ABBREVIATED PLAT AGENDA

October 30, 2024

**STAFF REVIEW AND RECOMMENDATIONS
PUBLIC HEARING
OCTOBER 30, 2024**

PRELIMINARY PLAT: LAZY SLUMBER
LEGAL DESCRIPTION: SEC 22, T18N, R02E, SEWARD MERIDIAN AK
PETITIONERS: ERON SINGLETON
SURVEYOR/ENGINEER: DENALI NORTH
ACRES: 12.08 ± PARCELS: 2
REVIEWED BY: NATASHA HEINDEL CASE #: 2024-108

TIMBERLINE SURVEYING AND MAPPING 17035 BARONOFF AVE EAGLE RIVER, AK 99577 907-242-5320 ryan@timberlinealaska.com DRAWN BY: R.G.J. FILE NO.: 24-034 SCALE: 1" = 100 FEET DATE: 7/3/2024 SHEET: 1 of 1

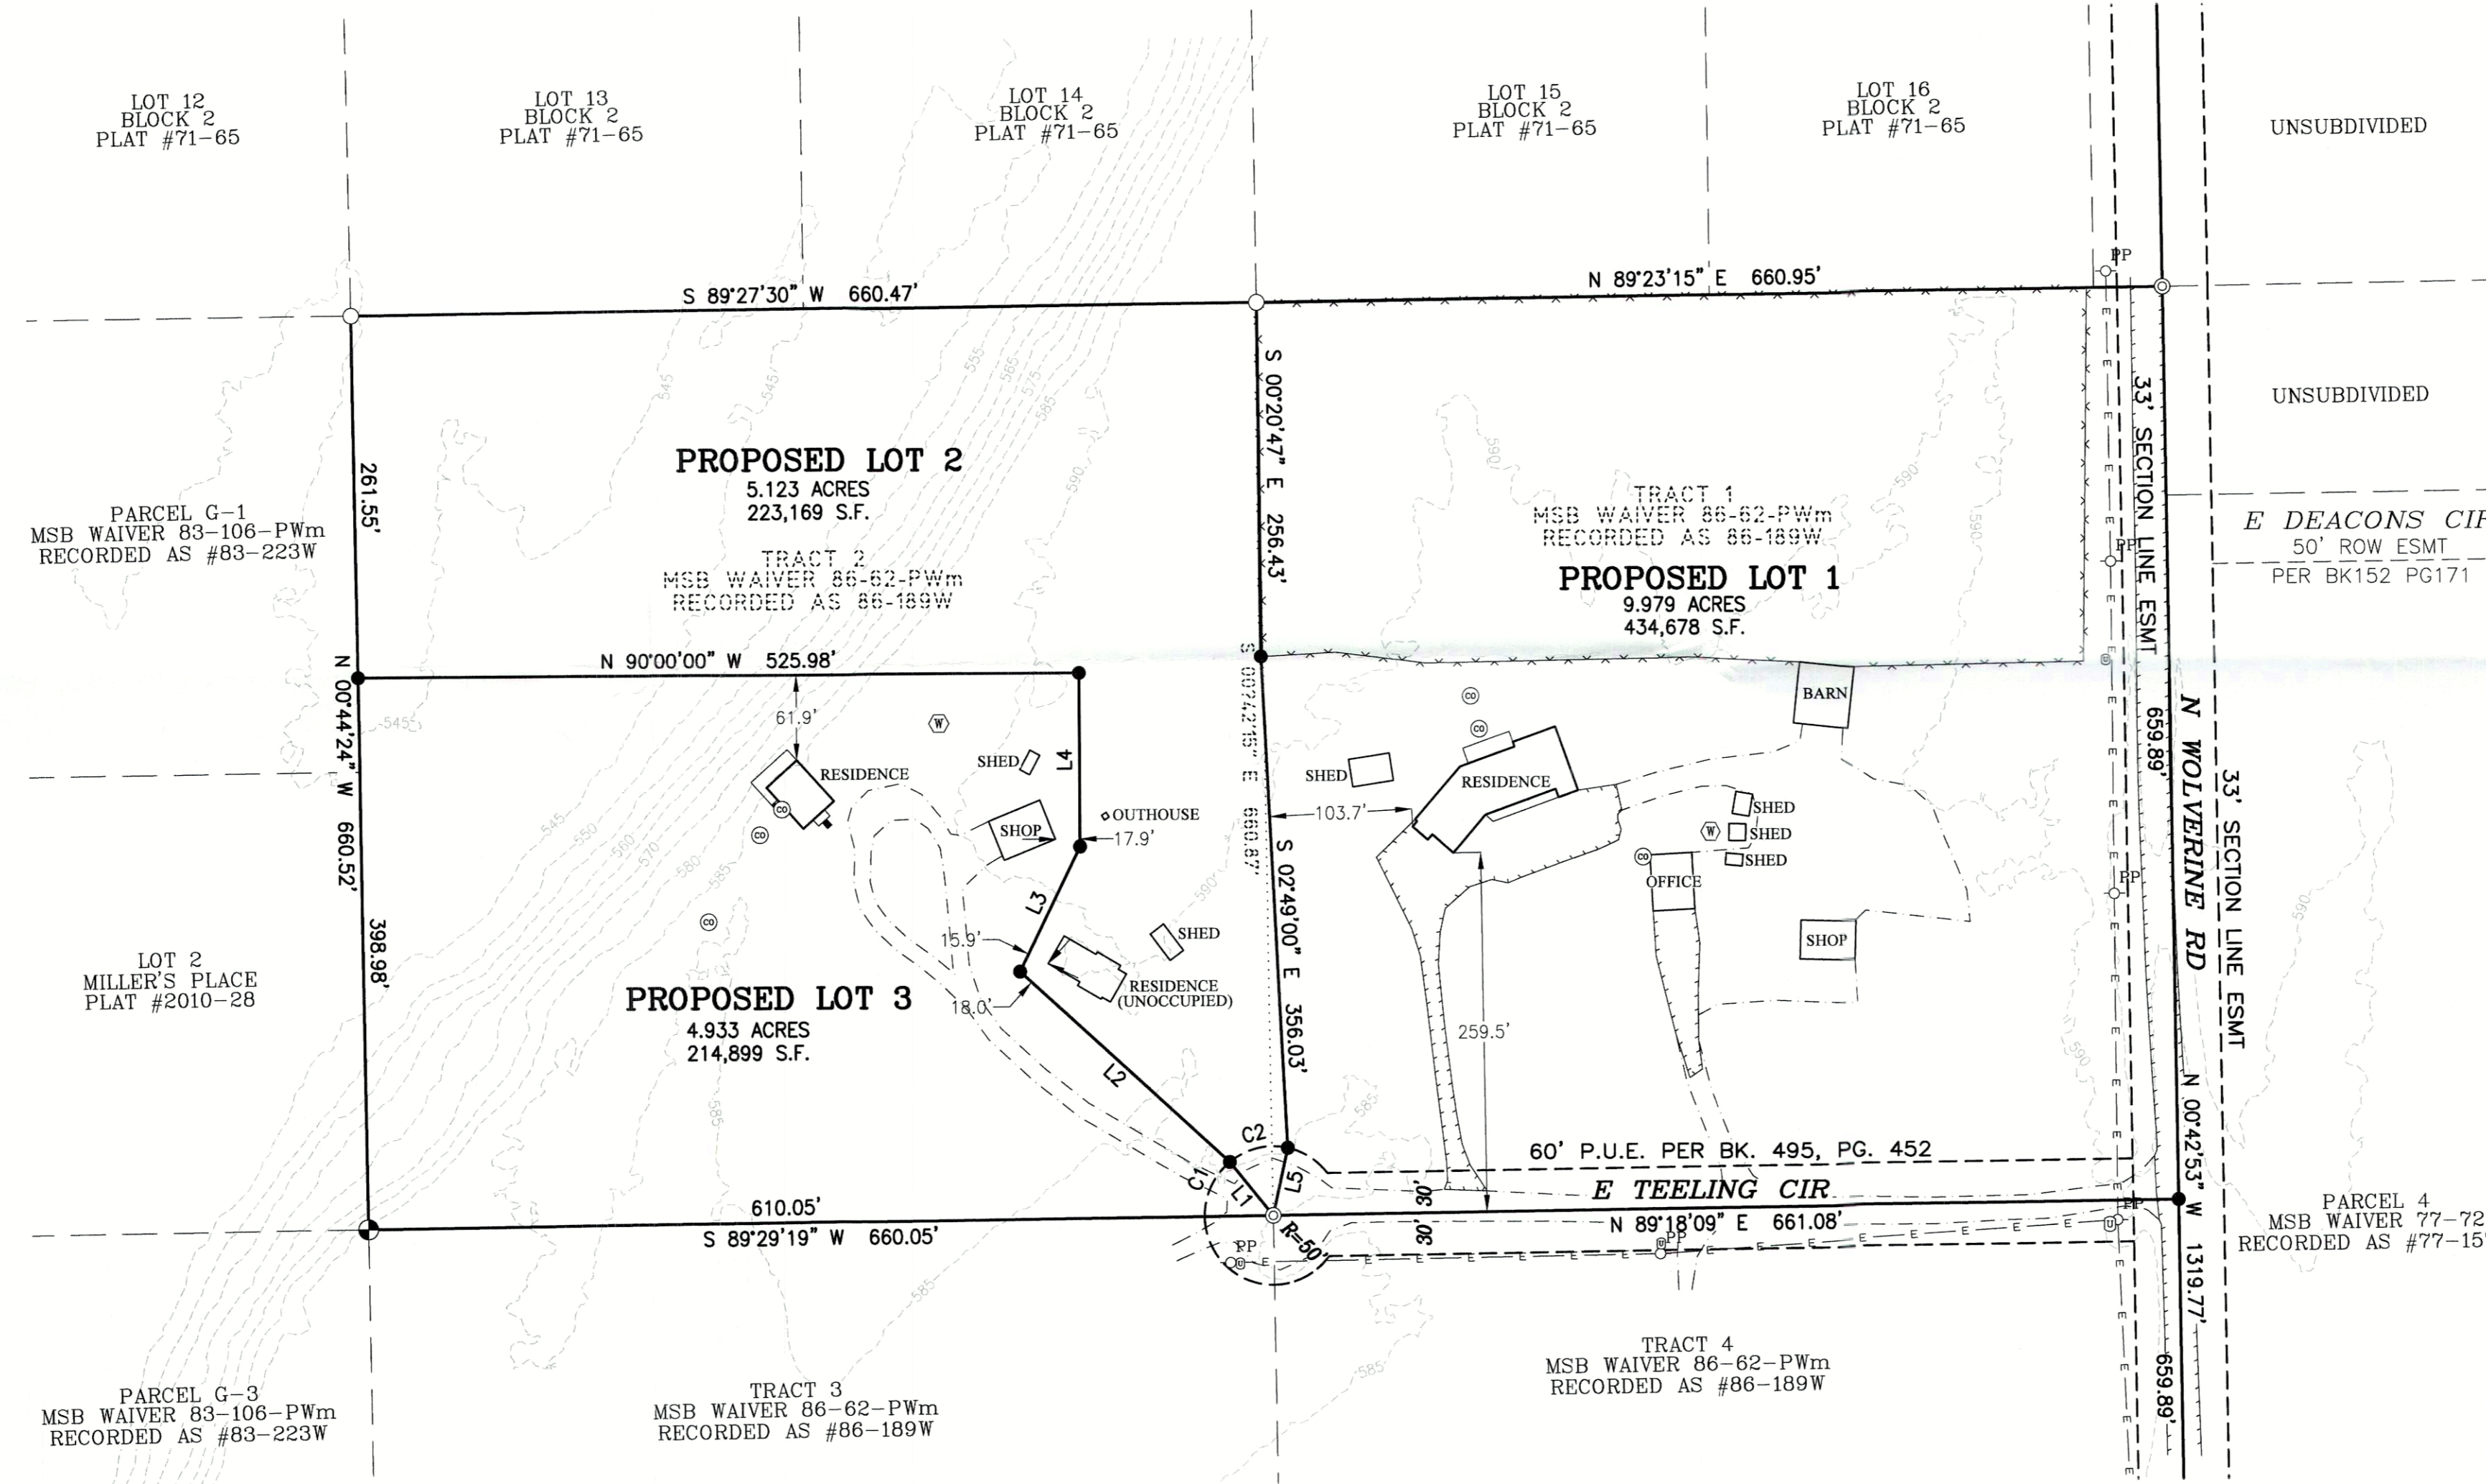
PD&E typically does not accept well drilling logs as proof of useable septic area. Based on Title 43.20.281, the existence of a septic system does not count as prove existence of useable area, "Water table and ability of soils to accept effluent shall be determined by a **number of borings or test holes** sufficient to indicate subsurface conditions over the entire area of the subdivision." The septic system certification does not depict subsurface conditions to a depth of 12'. Provide test hole logs including USCS symbols for the test hole that was dug on proposed lot 2 to a depth of 12'. Provide a figure showing the locations of all test holes dug on the property and include contours.
